**Telecommunications and exchange
between information technology
systems — Requirements for local and
metropolitan area networks —**

**Part 3:
Standard for Ethernet**

**AMENDMENT 5: Physical layers
specifications and management
parameters for 10 Mb/s operation and
associated power delivery over a single
balanced pair of conductors**

Reference number
ISO/IEC/IEEE 8802-3:2021/Amd.5:2021(E)

Figure 22-1—MII relationship to the ISO/IEC Open Systems Interconnection (OSI) reference model and the IEEE 802.3 CSMA/CD LAN model

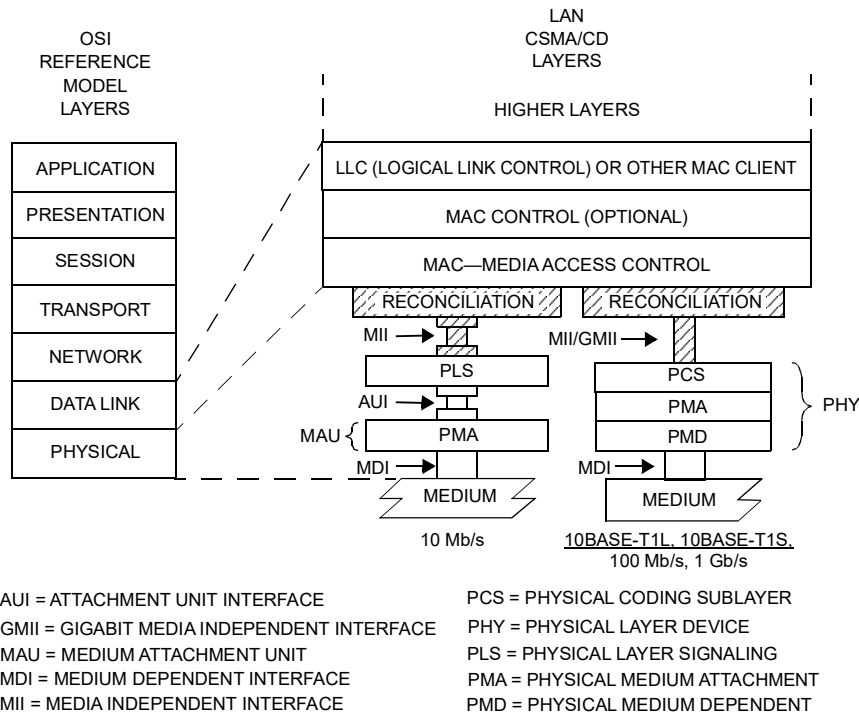
Change Figure 22-1 as follows (see changes at the bottom of the right column):

Figure 30-3—DTE System entity relationship diagram

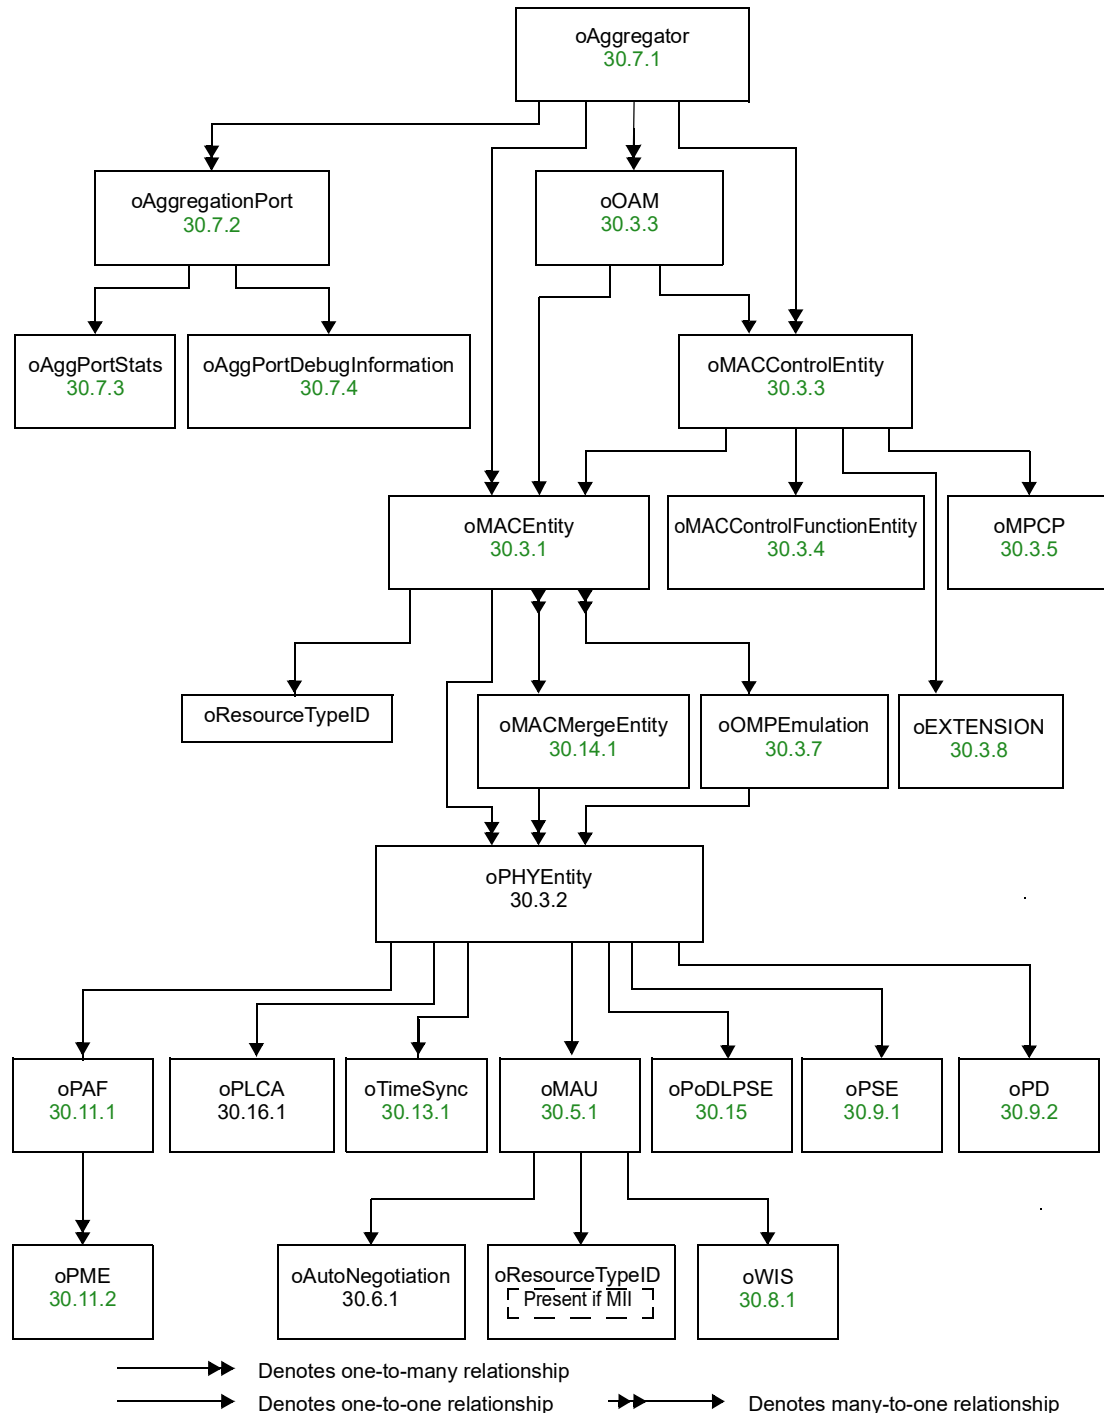
Replace Figure 30-3 with the following figure (which includes oPLCA):
